Figure 145-13—Top level PSE state diagram (continued)

Figure 145-13—Top level PSE state diagram (continued)
 fix for Class 0

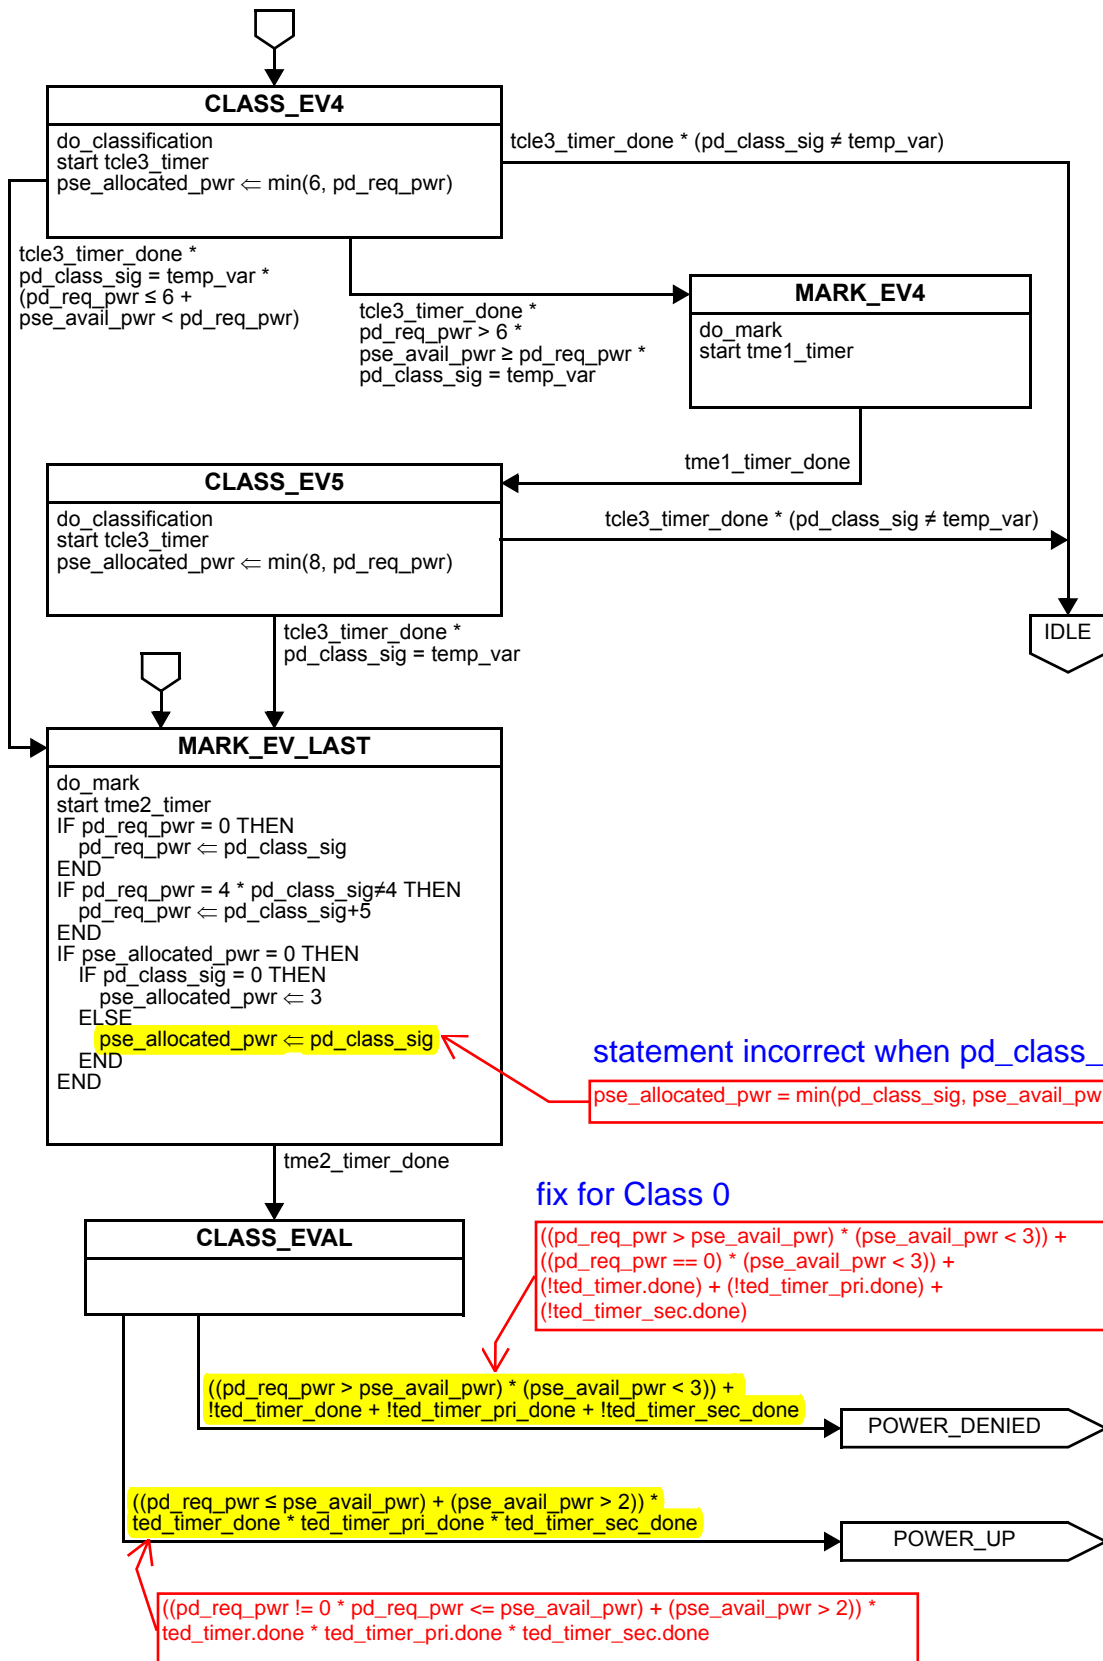
`pd_class_sig = 4 + !pd_4pair_cand + ...`

`pd_class_sig != 4 * pd_4pair_cand * ((pse_avail_pwr >= pd_class_sig+5) + pse_avail_pwr > 5)`

prevents getting stuck in CLASS_EV3 when need to power demote in EV4.

This to prevent issuing >3 class events when cannot 4P power.
